# Work Order ID 97862

Item Name: Crosstube Turning Detail

<b>DART AEROSPACE LTD</b>	<b>Work Order:</b>	<b>97862</b>
<b>Description: Crosstube Assembly (205/212/412 High Fwd)</b>	<b>Part Number:</b>	<b>D212-664-141</b>
<b>Inspection Dwg: D212-664-141 Rev: D</b>		<b>Page 1 of 2</b>

DRAWING NO. D212-664-141	TITLE XTUBE ASSY (205/212/412 HI FWD)	REV. D	DART AEROSPACE LTD ENGINEERING ORDER		D.E.O. NO. D212-664-141-D-1	SHEET NO. SHEET 1 OF 2	SCALE NTS
DRAWN	CHECKED	MFG. APPR.	APPROVED	DE APPR.			
DATE 11.04.07	DATE 11.04.11	DATE 11.04.12	DATE 11/04/12	DATE 11.04.12

**D212-664-141/-141B  
ASSEMBLY DETAIL**

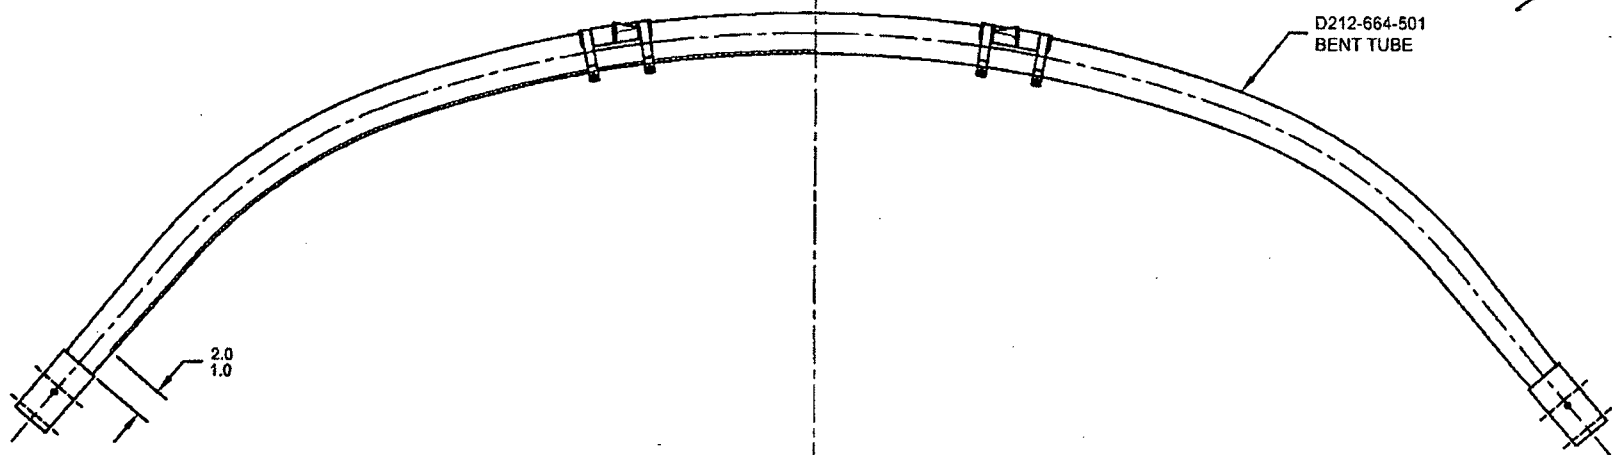
ADD AN INSPECTION WINDOW TO UNDERSIDE OF CROSSTUBE.

NOTES 2 OF SHEET 1 IS AMENDED AS FOLLOWS:

- 2) FINISH: CHEMICAL CONVERSION COAT PER DART QSI 005 4.1  
PRIME INSIDE AND OUTSIDE PER DART QSI 005 4.2  
MASK UNDERSIDE OF CROSSTUBE AS SHOWN (HATCHED AREA) AND  
PAINT OUTSIDE PER DART QSI 005 4.2  
REMOVE MASKING AND APPLY CLEAR COAT

- 2) FINISH: CHEMICAL CONVERSION COAT PER DART QSI 005 4.1  
PRIME INSIDE AND OUTSIDE PER DART QSI 005 4.2  
PAINT OUTSIDE PER DART QSI 005 4.2

MASK AREA PRIOR TO PAINTING.  
REMOVE MASKING AFTER PAINT  
AND APPLY CLEAR COAT
